ITEM FOR ENVIRONMENTAL BOARD AGENDA

**NAME & NUMBER
OF PROJECT:** Grace Lane Office Building / SP-2007-0552D

MEMORANDUM

Variance Request: Variance from LDC 25-8-341 and 342 to allow cut up to 11 feet and fill up to 14 feet for construction of a driveway.

Cut/Fill Exhibit 1

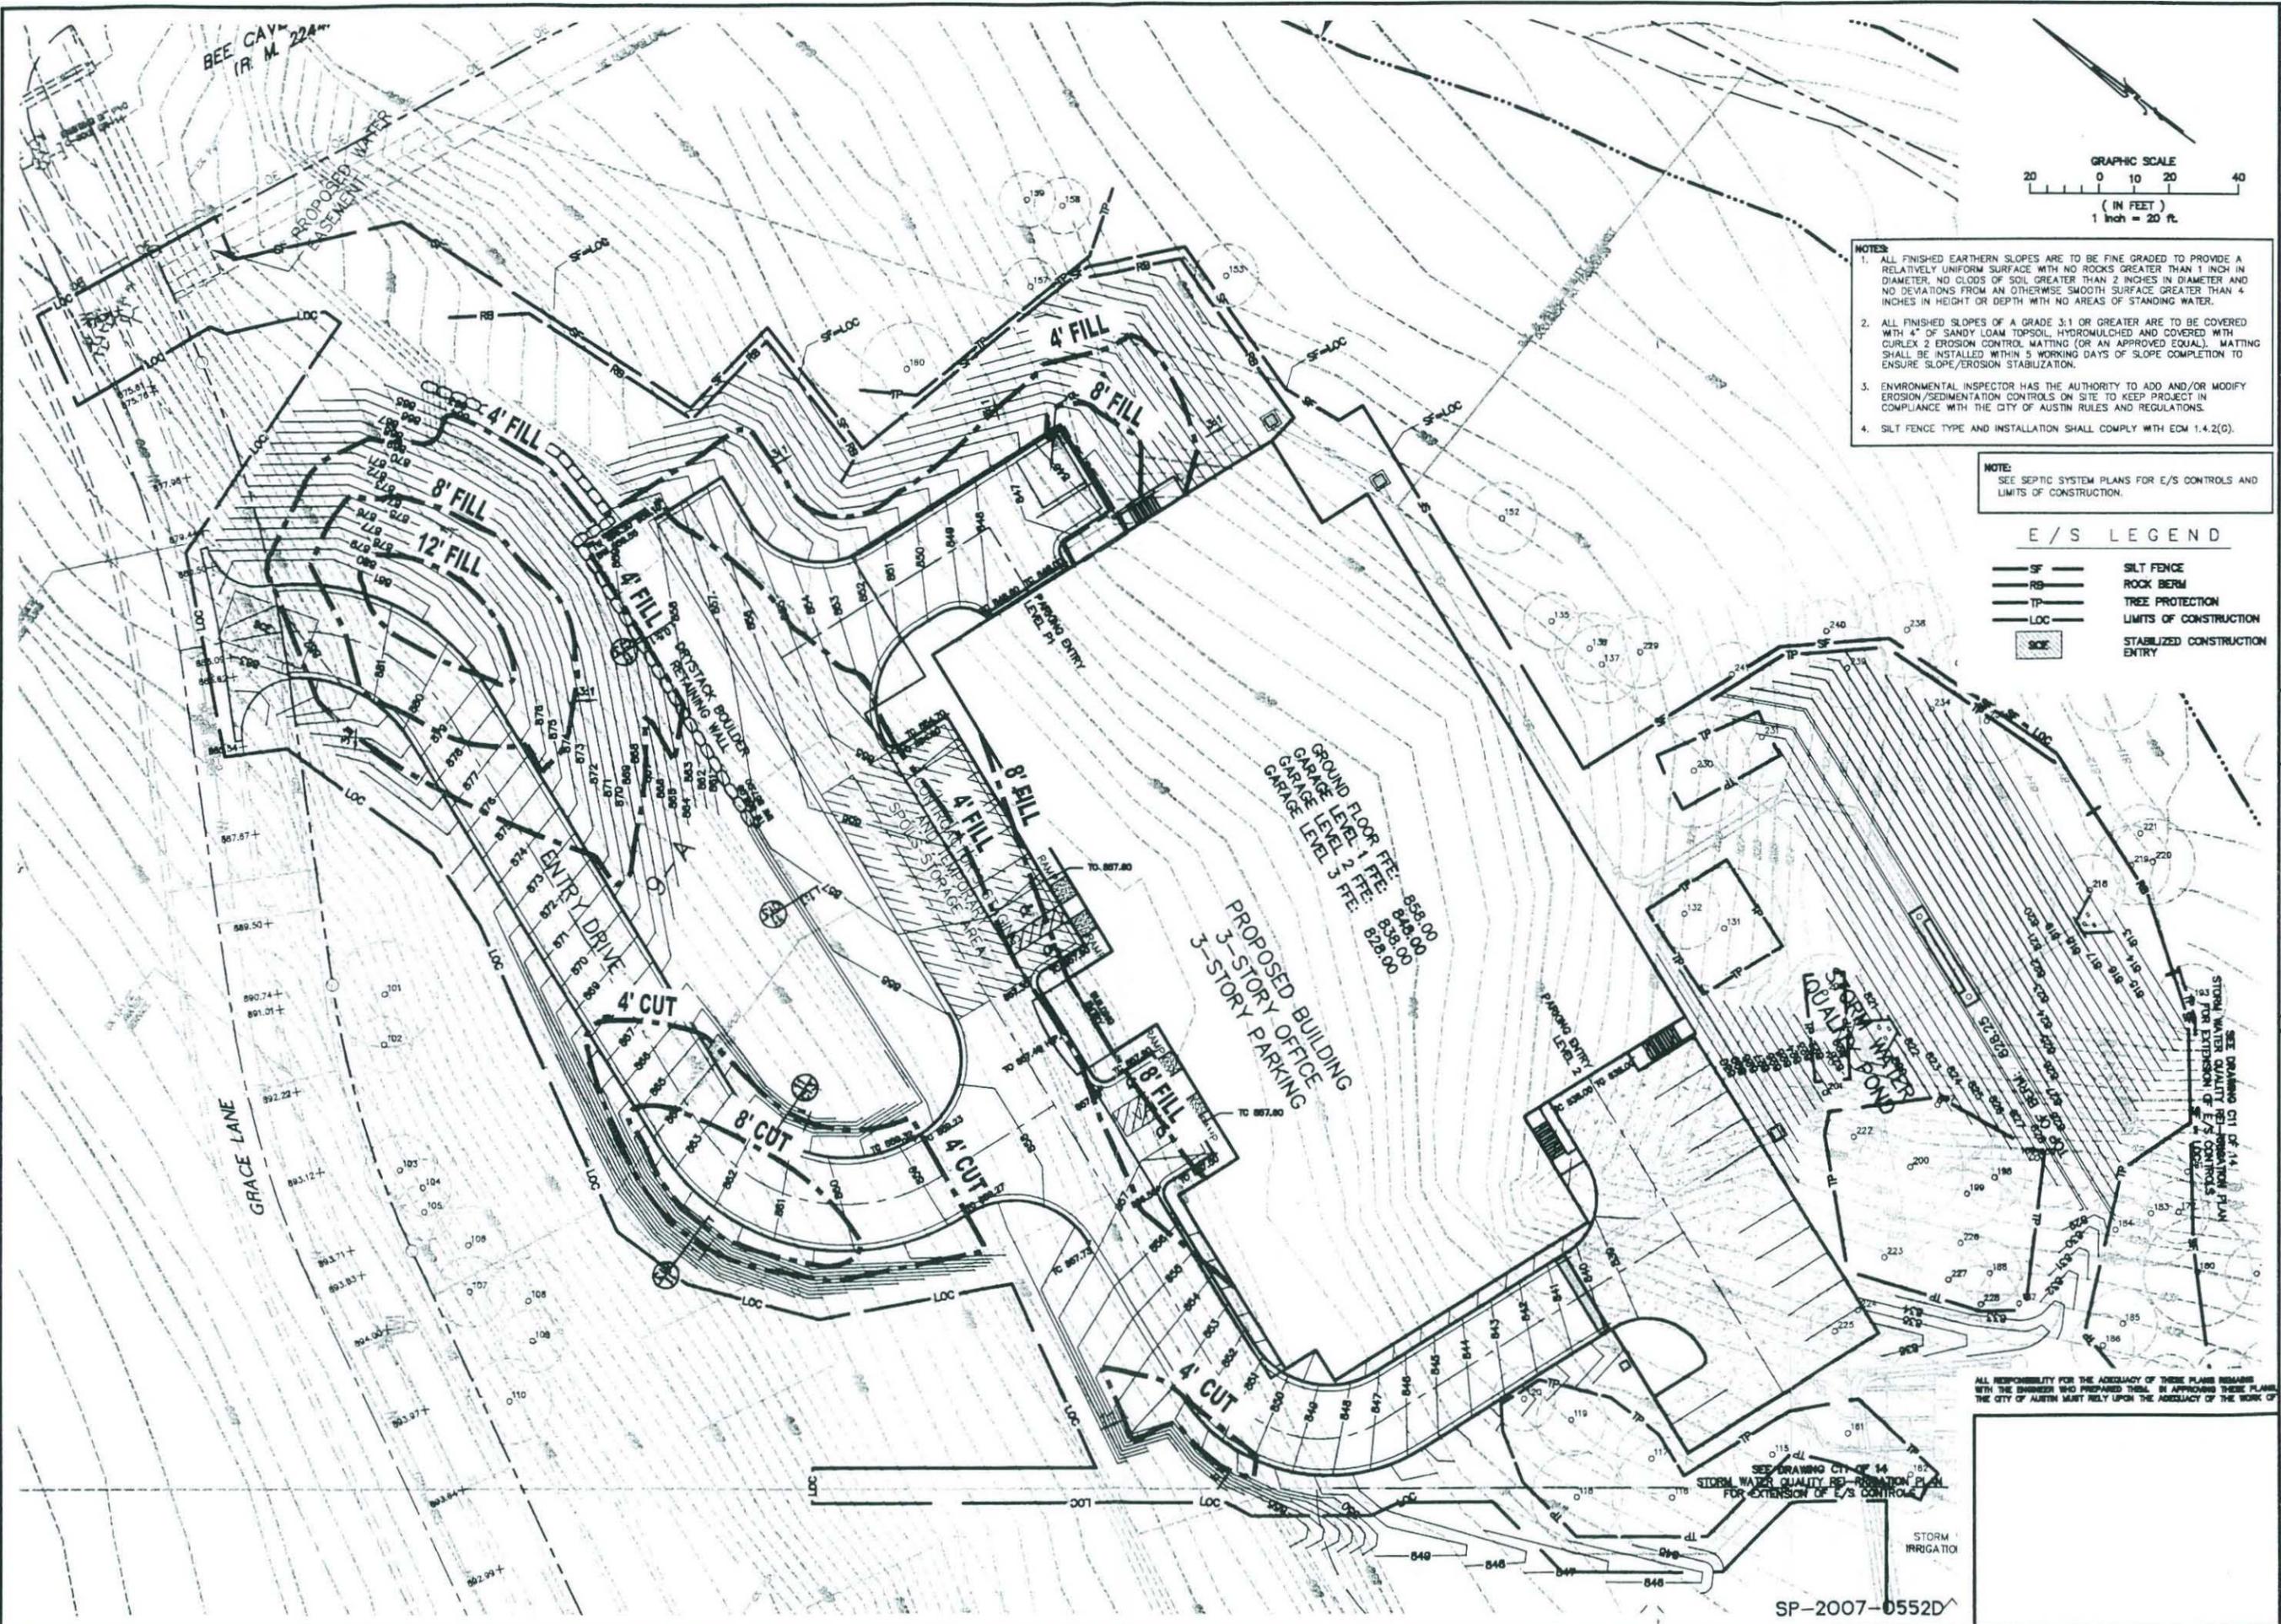
1. Variance from City Code Section 25-8-341- Allowing cut greater than 4 feet but less than 11 feet, and 25-8-342- Allowing fill greater than 4 feet but less than 14 feet.

Staff recommends granting the variance request because the findings of fact have been met. The applicant has proposed extensive revegetation and erosion controls for the fill.

Yes. The variance will not be providing a special privilege to the applicant. The site is situated at the corner of Bee Caves Road and Grace Lane. The building site is separated from Grace Lane by slopes of 15 – 35% in grade, requiring the driveway to the site from Grace Lane to cross steep slopes. Access to the site from Bee Caves Road (RR 2244) is prohibited by TxDOT.

Yes. The buildable area of the site is downslope from Grace Lane and access to that area is prohibited without construction of a driveway over a steep incline.

Yes. The location of the driveway will be over the less steep areas of the slope separating Grace Lane from the building site. The drive will run parallel to the slope for most of its length and incorporate nearly equal parts cut and fill to reach the building elevation. A maximum driveway grade of 14% is required for emergency vehicle access to the building, so the depth and extent of fill is dictated by this drive grade requirement.

Yes. The applicant has proposed a 3:1 slope of compacted limestone base, revegetated with a native grass mixture and native trees planted 30' on center. The applicant has utilized a retaining wall to reduce the footprint of the fill and erosion control matting will be placed on the slope to reduce the risk of erosion before the slope is adequately revegetated. In addition, the applicant will line the perimeter with a rockberm followed by a silt fence to create a barrier between the fill and the tributary downslope. A majority of the cut and fill will be upslope from the water quality catchment basin, which will further reduce the risk of sediment leaving the site.

Yes. A 3:1 slope, properly compacted and revegetated, will not pose a threat to water quality at the site. The proposed driveway location reduces the amount of impervious cover required for accessing the site than would be required if the drive entered from the adjacent property. It is requested that the applicant utilize extensive erosion control Best Management Practices (rock berms, erosion matting, silt fence) during the construction process to reduce the risk of sediment erosion before the slope is revegetated.

- (1) The applicant will stabilize and restore the areas of fill with: 1.) City of Austin Standard 604s Seeding for Erosion Control and; 2.) provide native Class I or II Hill Country species trees planted 30 feet on center.
- (2) The applicant will provide enhanced erosion and sedimentation controls below the fill area to ensure all eroded sediments remain on site. The areas of fill will be completely encircled by a rockberm on the downhill side followed by silt fence. The slope will be covered with erosion matting until the revegetation is fully established.
- (3) The applicant will limit cut to 11 feet and fill to 14 feet.
- (4) All slopes created from fill material will be less than or equal to a 3:1 slope.
